The Commission has issued the enclosed Amendments Nos. 45, 45, and 42 for Licenses Nos. DPR-38, DPR-47 and DPR-55 for the Oconee Nuclear Station, Units 1, 2 and 3. These amendments consist of changes to the Station's common Technical Specifications and are in response to your request dated May 6, 1977, as supplemented June 21, and July 11, 1977, and your request dated March 1, 1977, as supplemented May 5, 1977.

These amendments revise the Technical Specifications (1) to establish operating limits for Unit 2 Cycle 3 operation and (2) to establish requirements for testing reactor core internal vent valves.

DUKE POWER COMPANY

OCONEE NUCLEAR STATION, UNIT NO. 1

Figure 2.1-1B

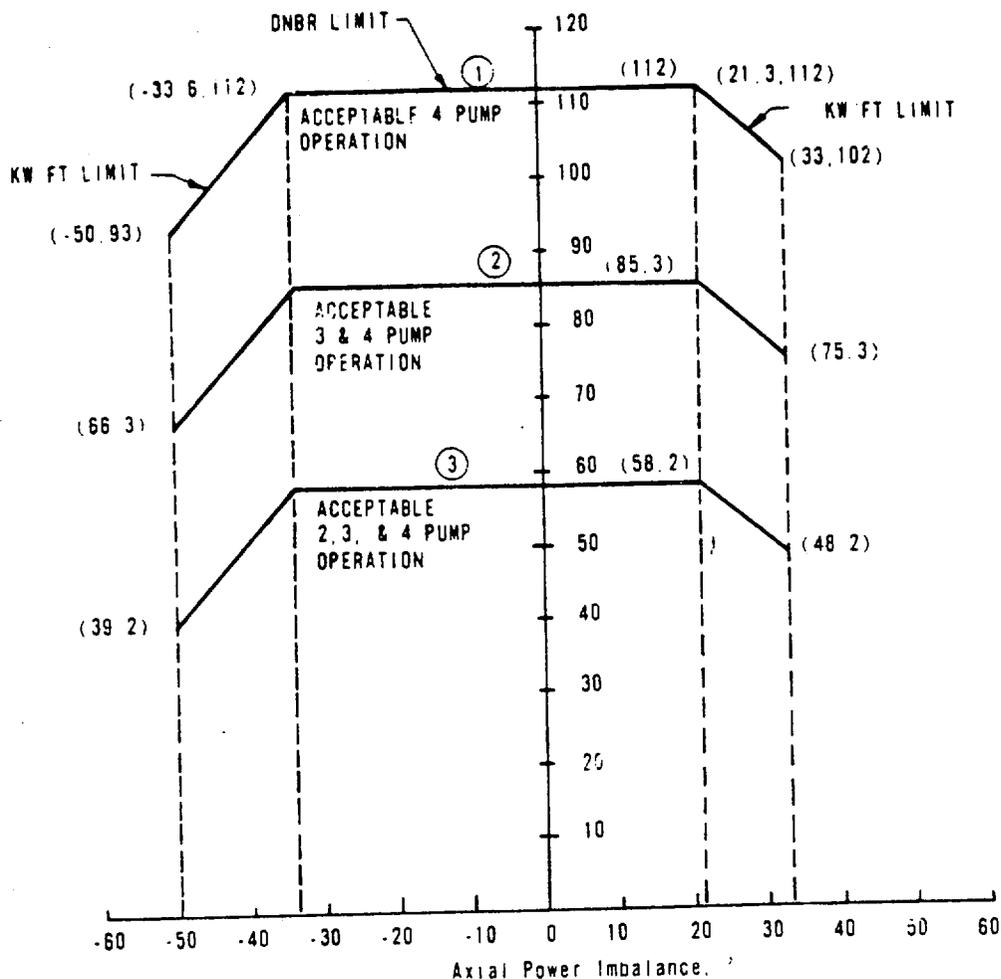
The curve of Figure 2.1-1B is the most restrictive of all possible reactor coolant pump-maximum thermal power combinations shown in Figure 2.1-3B.

For each curve of Figure 2.1-3B, a pressure-temperature point above and to the left of the curve would result in a DNBR greater than 1.30 or a local quality at the point of minimum DNBR less than 22 percent for that particular reactor coolant pump situation. The 1.30 DNBR curve for four-pump operation is more restrictive than any other reactor coolant pump situation because any pressure/temperature point above and to the left of the four-pump curve will be above and to the left of the other curves.

UNIT 2  
 CORE PROTECTION SAFETY LIMITS  
 OCONEE NUCLEAR STATION  
 Figure 2.1-2B

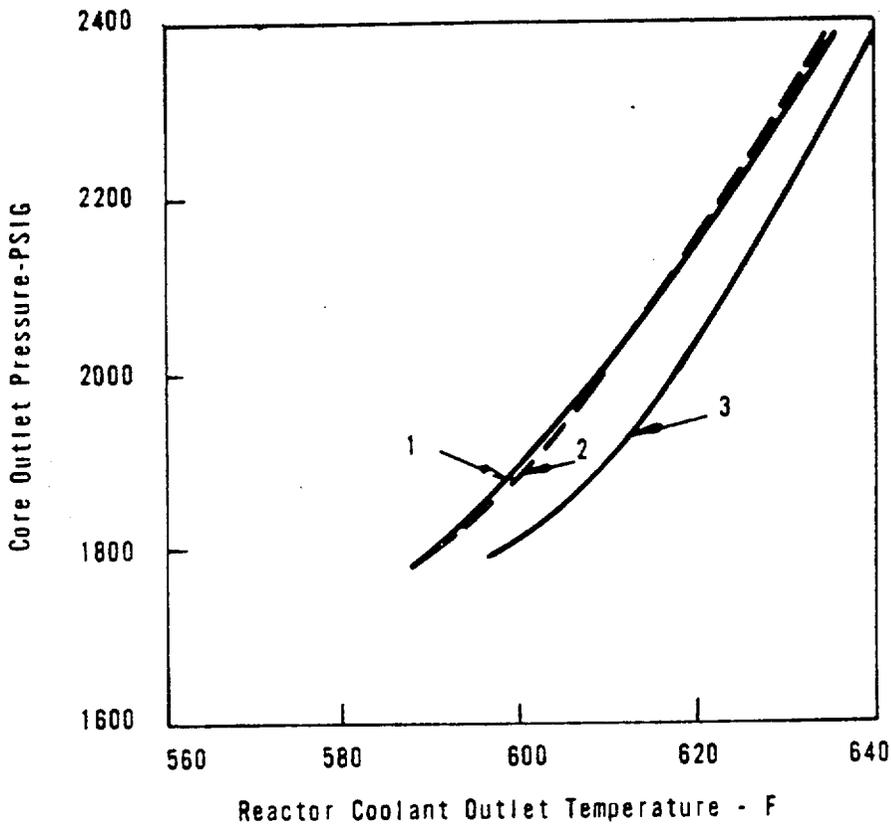
The curves of Figure 2.1-2B are based on the more restrictive of two thermal limits and include the effects of potential fuel densitication and fuel rod bowing:

The specified flow rates for Curves 1, 2, and 3 of Figure 2.1-2B correspond to the expected minimum flow rates with four pumps, three pumps, and one pump in each loop, respectively.

Figure 2.3.1B

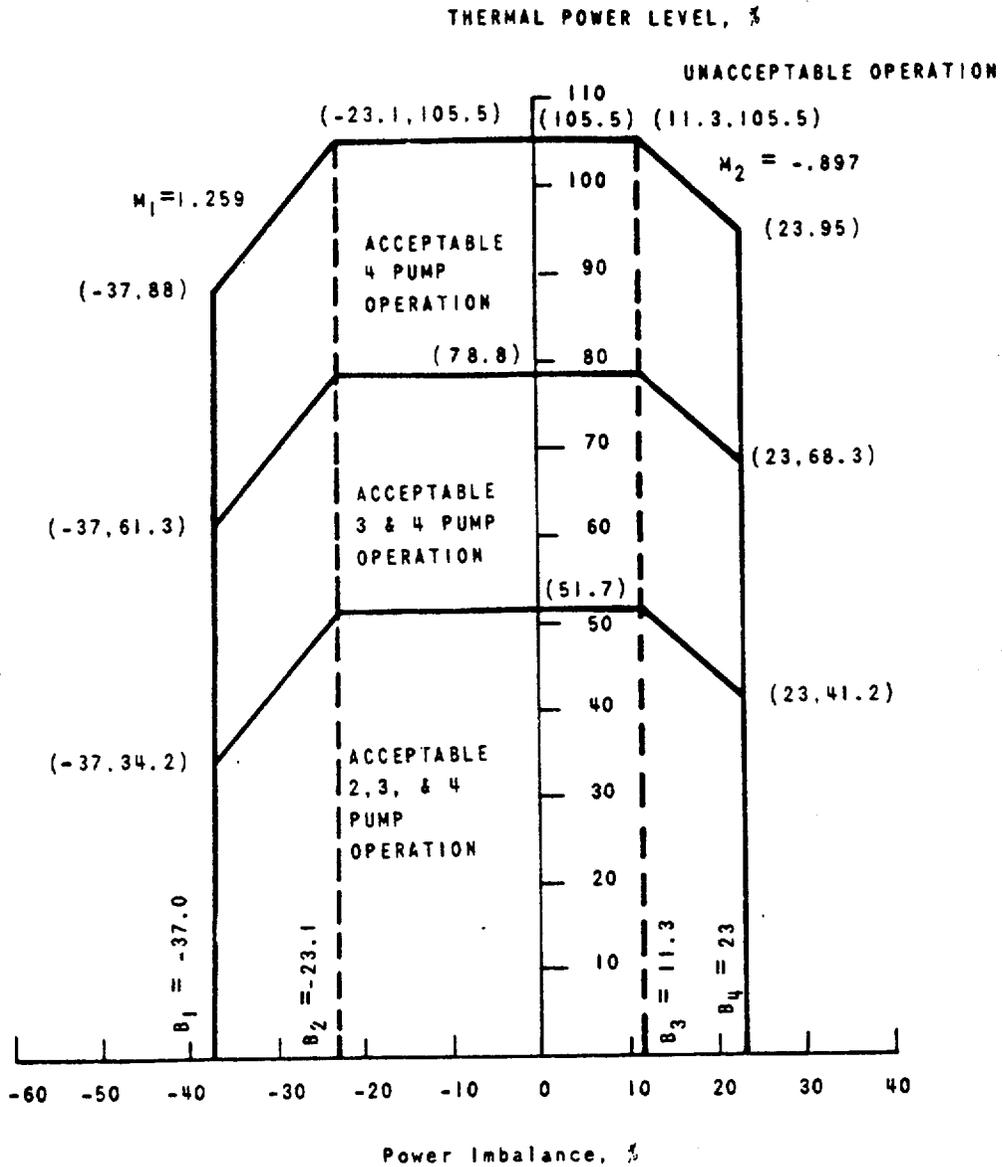
During a startup accident from low power or a slow rod withdrawal from high power, the system high pressure set point is reached before the nuclear over-power trip set point. The trip setting limit shown in Figure 2.3-1A - Unit 1

for high reactor coolant system pressure (2355 psig) has been established to maintain the system pressure below the safety limit (2750 psig) for any design transient. (1)

The low pressure (1800) psig and variable low pressure (11.14 T<sub>out</sub>-4706) trip (1800) psig (11.14 T<sub>out</sub>-4706) (1800) psig (10.79 T<sub>out</sub>-4539)

setpoints shown in Figure 2.3-1A have been established to maintain the DNB 2.3-1B 2.3-1C

Figure 3.5.2-1B1

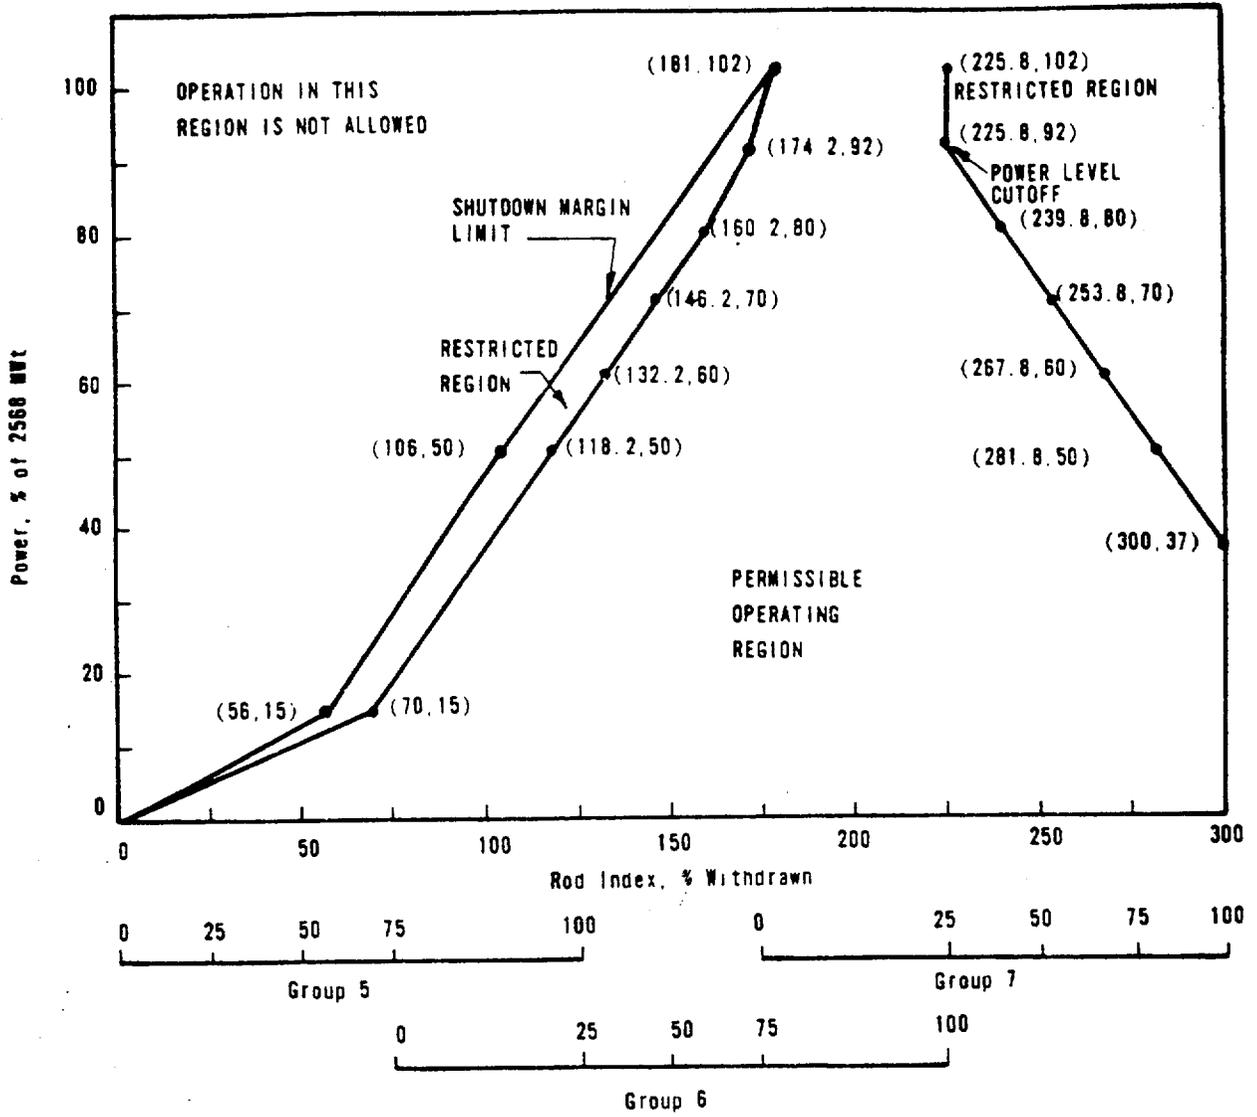
d. Except for physics tests, power shall not be increased above the power level cutoff as shown on Figures 3.5.2-1A1, 3.5.2-1A2 (Unit 1), 3.5.2-1B1, 3.5.2-1B2, and 3.5.2-1B3 (Unit 2), and 3.5.2-1C1, 3.5.2-1C2, 3.5.2-1C3 (Unit 3), unless the following requirements are met.

Figure 3.5.2-3B2

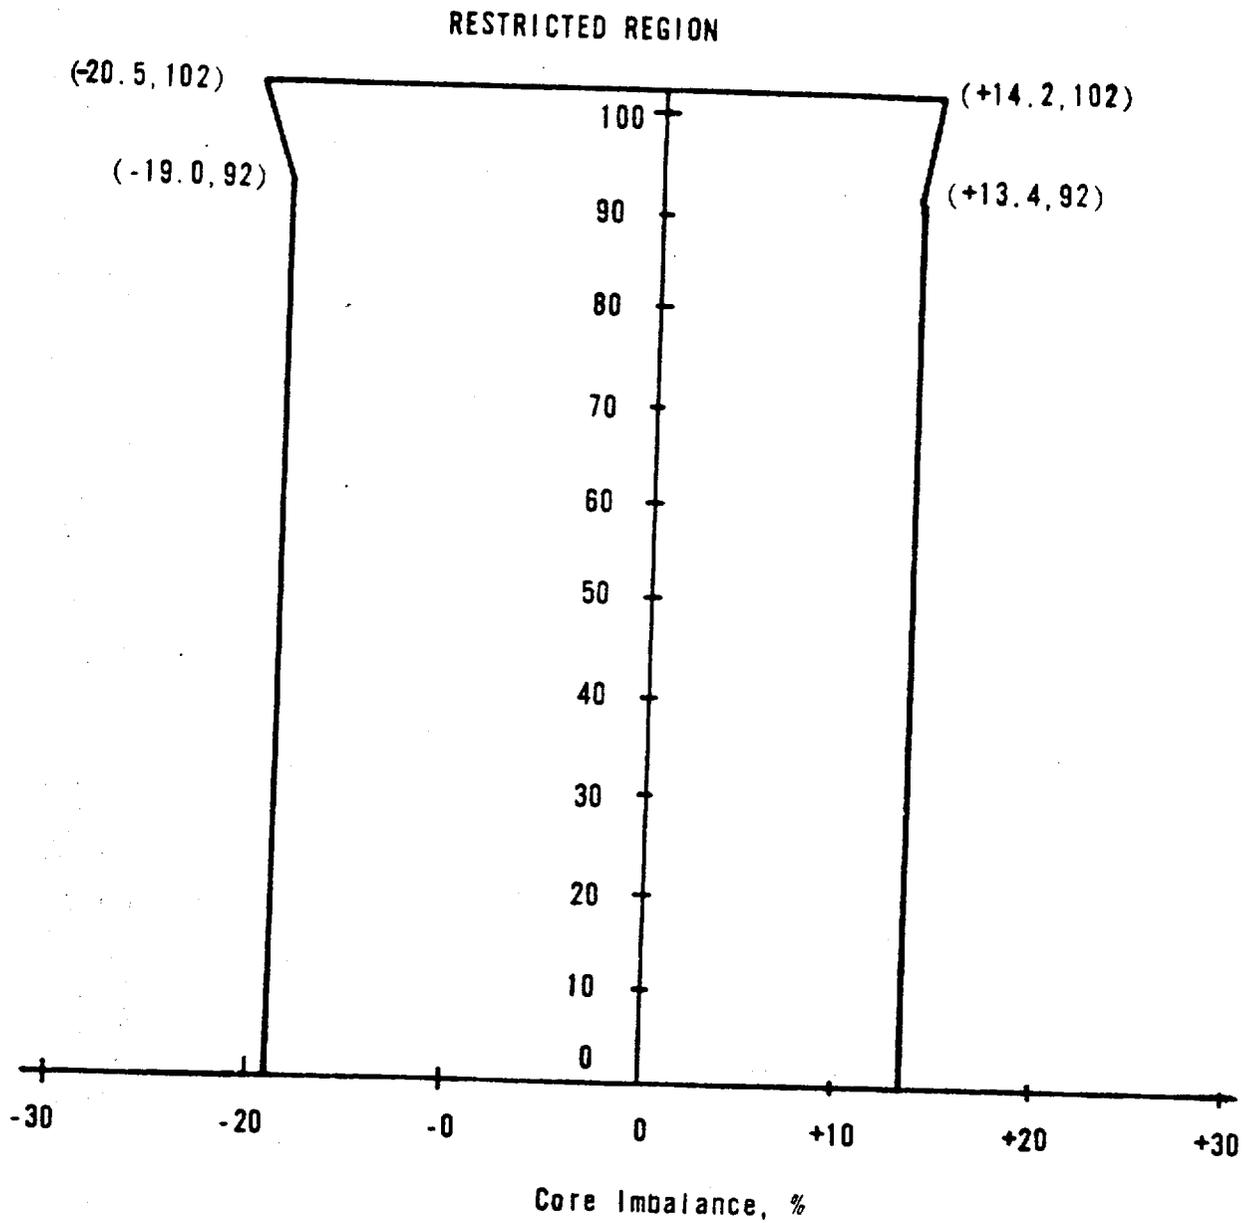
The power-imbalance envelope defined in Figures 3.5.2-3A1, 3.5.2-3A2, 3.5.2-3B1, 3.5.2-3B2, 3.5.2-3B3, 3.5.2-3C1, 3.5.2-3C2 and 3.5.2-3C3 is based on LOCA analyses which have defined the maximum linear heat rate (see Figure 3.5.2-5) such that the maximum clad temperature will not exceed the Final Acceptance Criteria. Corrective measures will be taken immediately should the indicated quadrant tilt, rod position, or imbalance be outside their specified boundary. Operation in a situation that would cause the Final Acceptance Criteria to be approached should a LOCA occur is highly improbable because all of the power distribution parameters (quadrant tilt, rod position, and imbalance) must be at their limits while simultaneously all other engineering and uncertainty factors are also at their limits.\*\* Conservatism is introduced by application of:
